2020 Royal Alloy Grand Tourer 150 Recall Instructions - EDITED

Technical Issue:

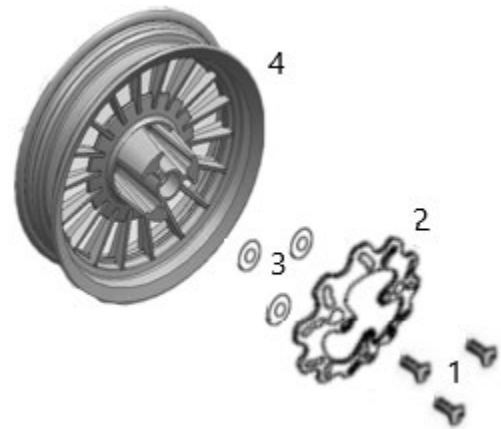
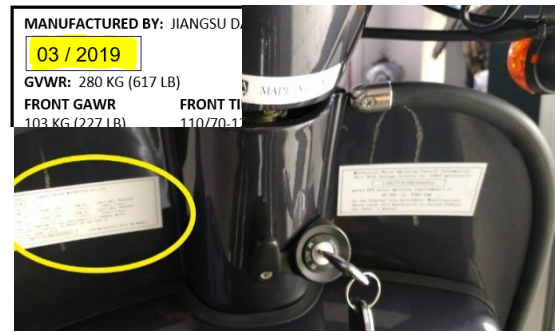
During operation, the front brake rotor can become uncentered within the front brake caliper causing the innermost brake pad to dislodge from the top of the brake caliper. This could result in reduced or a complete loss of braking ability in both the front and rear brake systems as they are linked.

To remedy, the brake rotor will be repositioned with spacers to prevent the front brake pads from dislodging from the front brake caliper. This problem will be resolved at no charge to the consumer.

- 1) Place a large metal punch tool over the head of the brake rotor bolt (1).
- 2) Strike the punch a few times with a hammer prior to extraction. Video: <https://youtu.be/UPZp9kqcnnY>

- 3) Remove brake rotor mounting bolt and discard.
- 4) Repeat steps 1-3 until all brake rotor bolts have been removed from the wheel.
- 5) Install Spacer (3) supplied between the Wheel (4) and brake Rotor (2) at the mounting point.

- 6) Locate the new rotor mounting bolts supplied in recall parts package. Begin the bolt tightening process by hand to prevent cross-threading and then tighten bolt till snug. DO NOT APPLY THREADLOCK OR TORQUE UNTIL LATER STEP.

- 7) Repeat step 2 and 3 above for the second bolt.
- 8) Repeat step 2 for the third and final mounting location, then place blue thread-locker on the new bolt. Begin the bolt tightening process by hand to prevent cross-threading. Torque bolt to 18.4 ft-lb or 25 Nm.

- 9) Remove one of the previously tightened bolts and apply blue thread-locker. Begin the bolt tightening process by hand to prevent cross-threading. Torque bolt to 18.4 ft-lb or 25 Nm.

- 10) Remove the last of the previously tightened bolts and apply blue thread-locker. Begin the bolt tightening process by hand to prevent cross-threading. Torque bolt to 18.4 ft-lb or 25 Nm.

- 11) Visually verify spacers are installed flush with wheel and rotor. Spin front wheel and visually verify rotor does not wobble from left to right.
- 12) Take vehicle for a test ride to ensure brake system is functioning properly.
